Subject: Request for Class 2 Permit Modification to the Los Alamos National Laboratory (LANL) Hazardous Waste Facility Permit for Technical Area 54, Building 38, West, EPA ID No. NM0890010515

**Class 2 Permit Modification Request for  
Technical Area 54, Building 38 (TA-54-38) West  
Los Alamos National Laboratory Hazardous Waste Facility Permit  
January 2013**

**LA-UR-12-27049**

**Figure G.16-1:** Technical Area 54, Building 38 (High, Low Bay, and Loading Dock Sampling Locations)

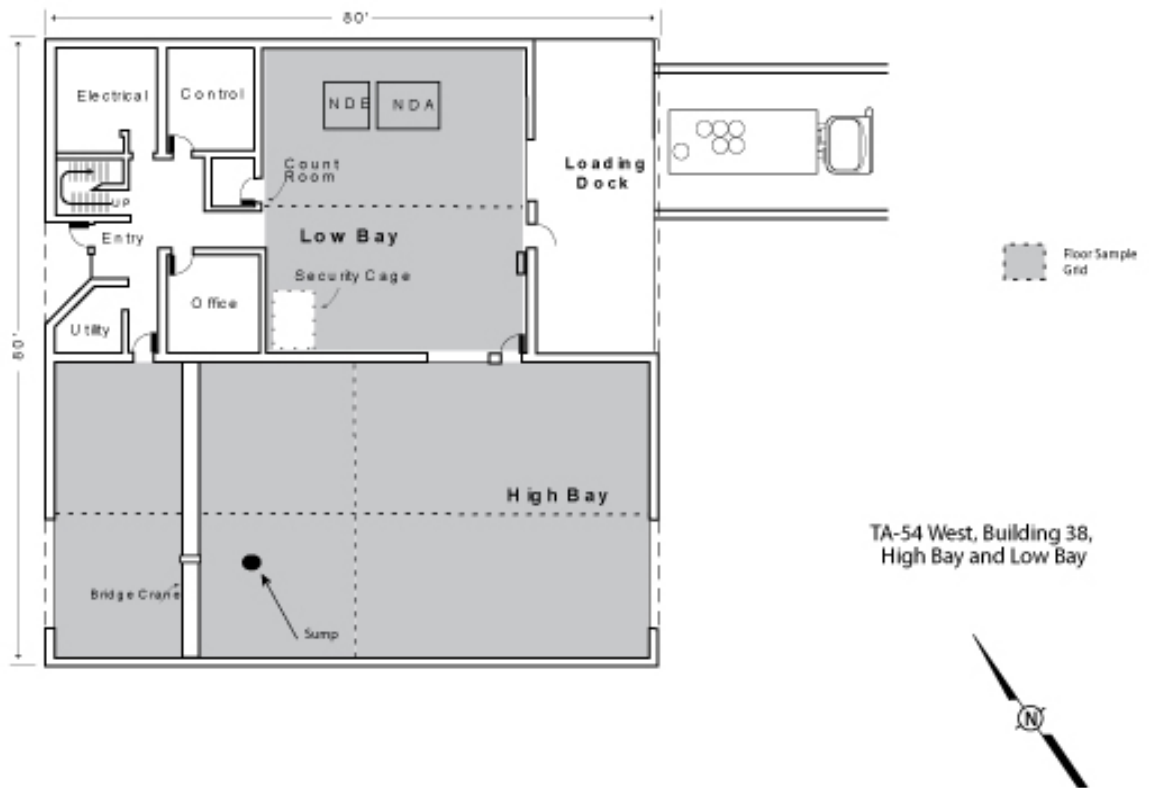
Attachment G.16, Figure G.16-1	Figure has been replaced.	Change has been made to illustrate the larger footprint of the entire High Bay and Low Bay as the permitted unit boundary, incorporate sample areas for the larger footprint, and remove the loading dock sample locations.
Attachment G.17, Section 6.1, Last paragraph	Sample locations for the loading dock have been added.	Change has been made to correct the location of the loading dock sampling requirements within the closure plans.
Attachment G.17, Figure G.17-1	Figure has been replaced.	Change has been made to correct the location of the loading dock sample areas within the closure plans. The figure was also changed to remove a structure (357) that does not exist at the unit and is not included within either Figures 9 or 37 in Attachment N.
Attachment J, TA-54, West Indoor	Operating capacity has been increased.	Change has been made to increase the operating capacity of the unit to allow the flexibility of managing shipments of larger containers.

- a. ~~four~~ nine wipe samples from the High Bay (*see* Figure G.16-1):
1. ~~two~~four from the floor;
  2. one from ~~the~~each wall; and
  3. one from the sump;
- b. ~~one~~six wipe samples s from the Low Bay (*see* Figure G.16-1):
1. two from the floor; and
  2. one from each wall.
- c. ~~one from the floor; and~~
- d. ~~two wipe samples from the Loading Dock areas identified as 'sample area 1' and 'sample area 2' (*see* Figure G.16-1)~~

**Figure G.17-1: Technical Area 54 West Outdoor Container Storage Unit Grid Sampling and Additional Sampling Locations**

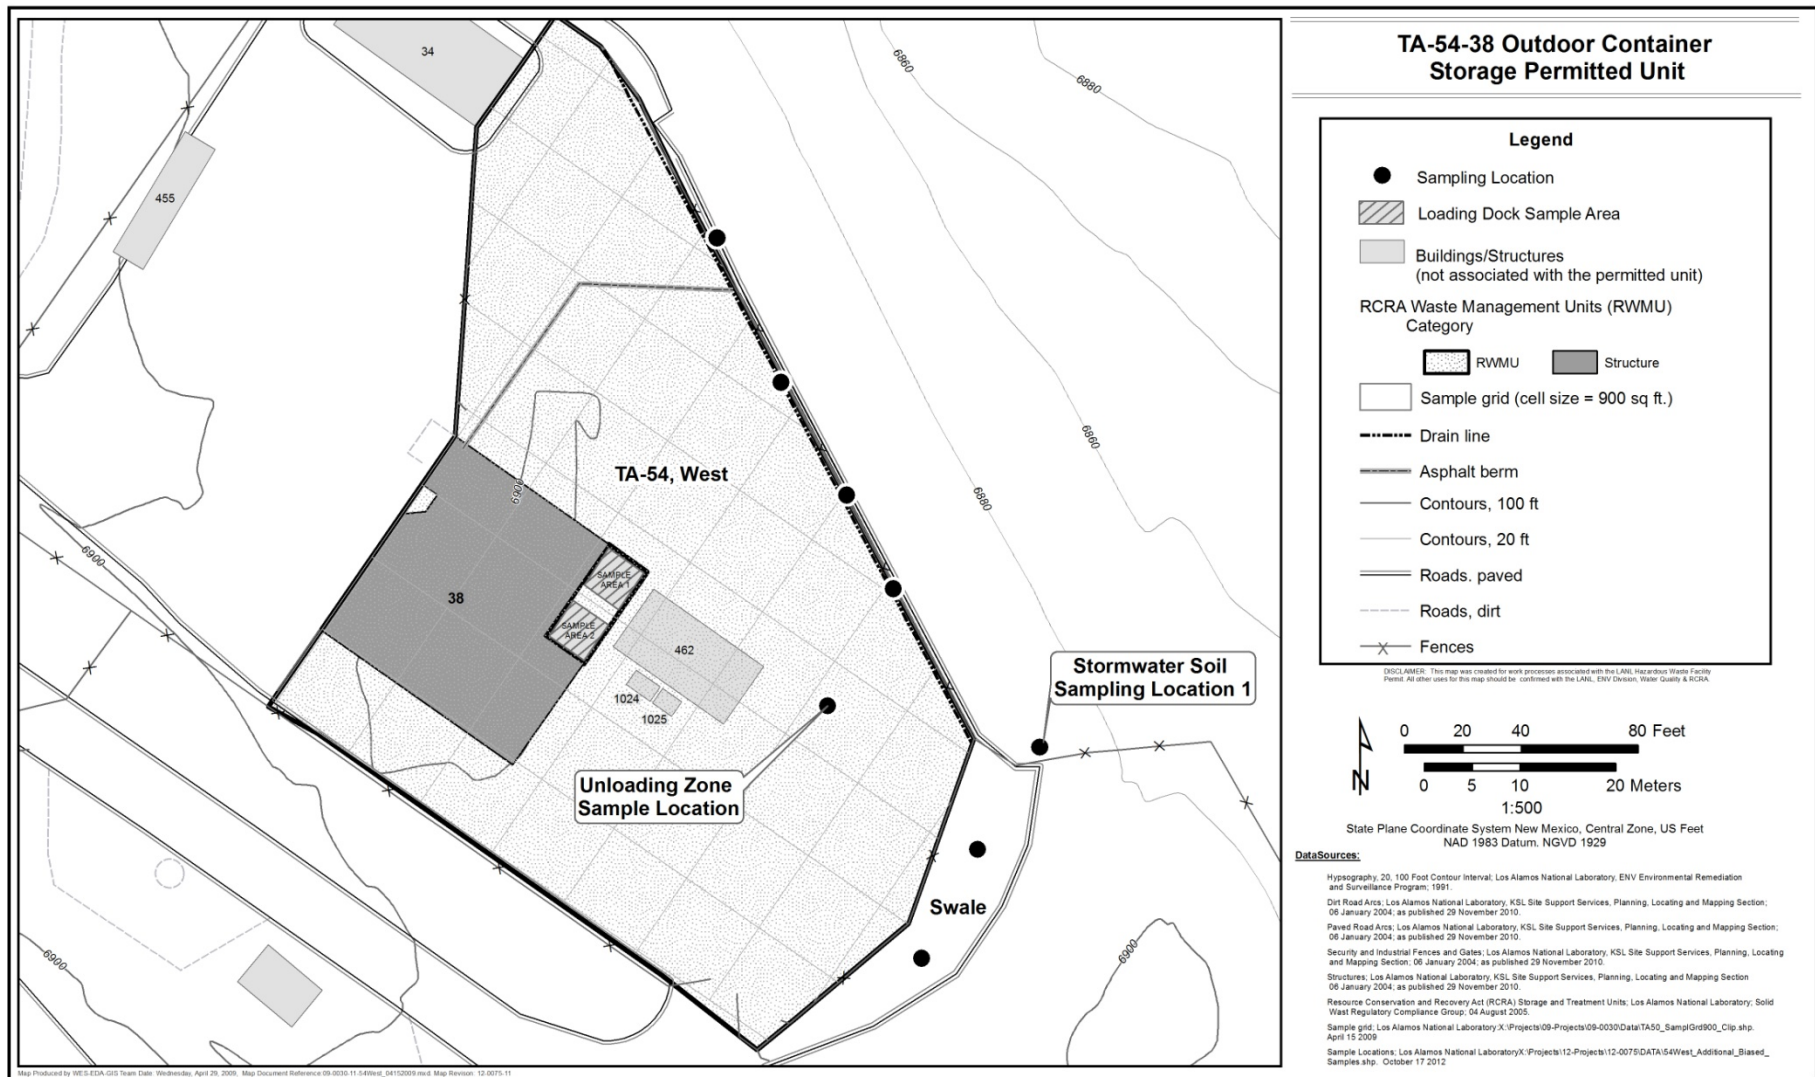
Permit Attachment G.17, *Technical Area 54 West, Outdoor Container Storage Unit Closure Plan*, has been revised in Sections 6.1 and on Figure G.17-1 to add references to the loading dock. Section 2.0 of the closure plan already includes an accurate description of the loading dock; therefore, no changes were made to that section of the closure plan. Section 6.1 has been revised to include the sample locations for the loading dock that were previously included in Permit Attachment G.16. The sample areas have also been added to Figure G.17-1.

An additional two wipe samples are required from the Loading Dock areas identified as 'Sample Area 1' and 'Sample Area 2.' Figure G.17-1 illustrates the sampling locations discussed in this section.

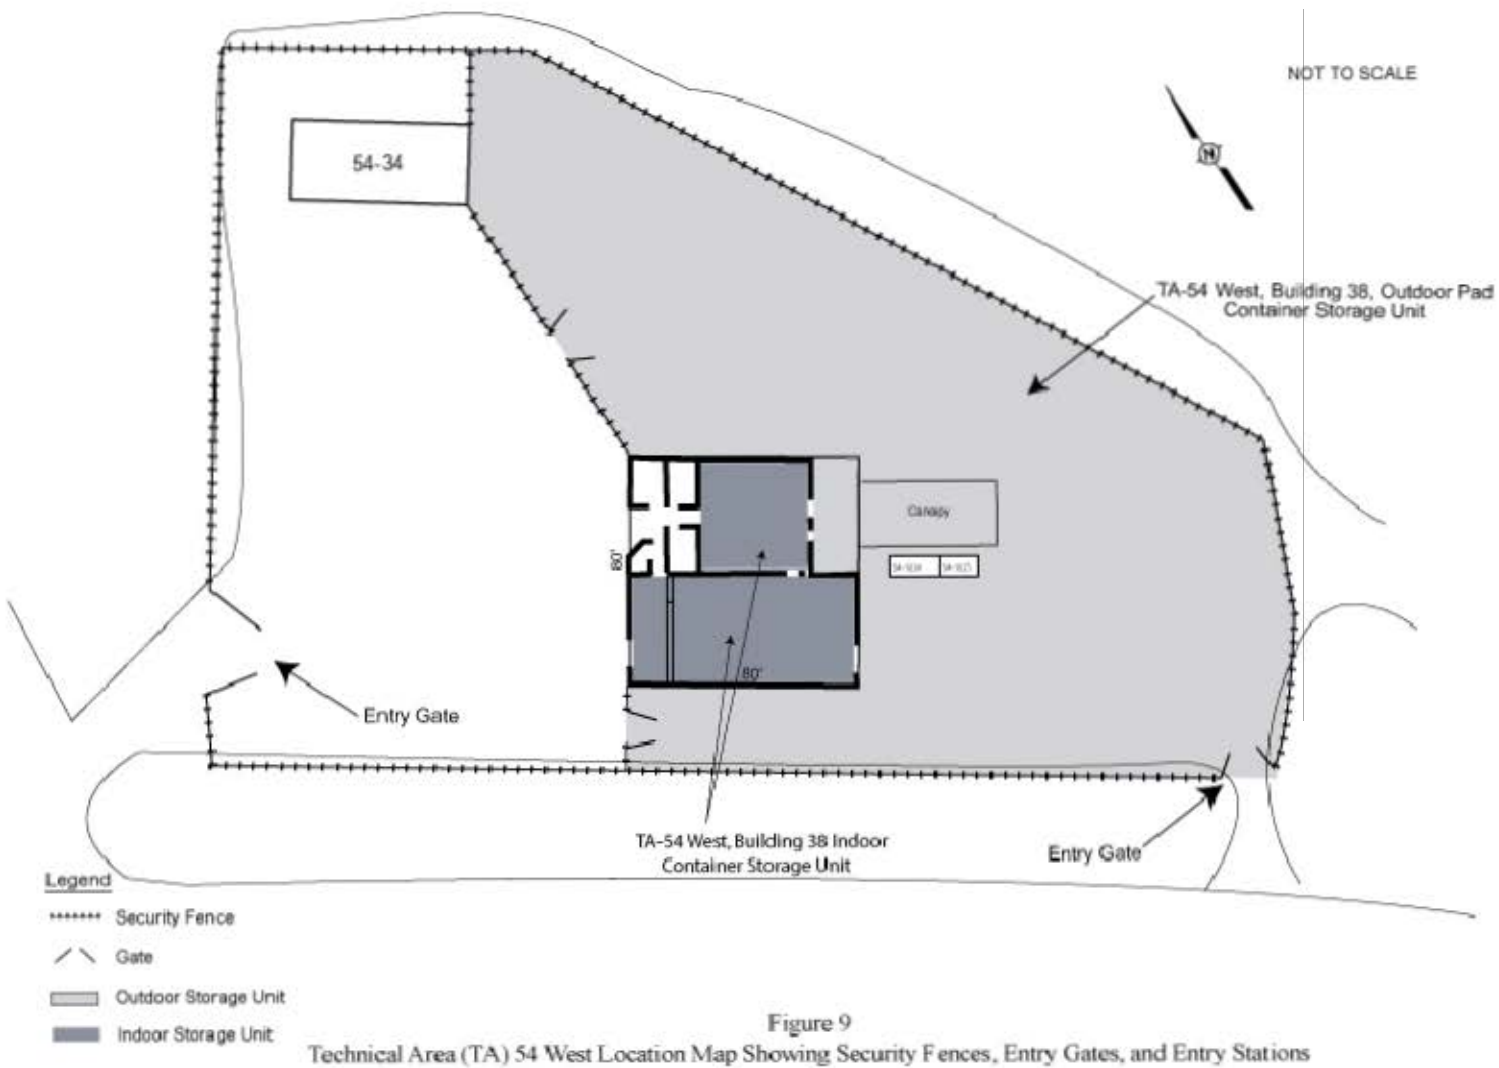
Figures 9 and 37 within Permit Attachment N, *Figures* have been updated to include the entire High Bay and Low Bay as part of the TA-54-38 West Indoor Unit.
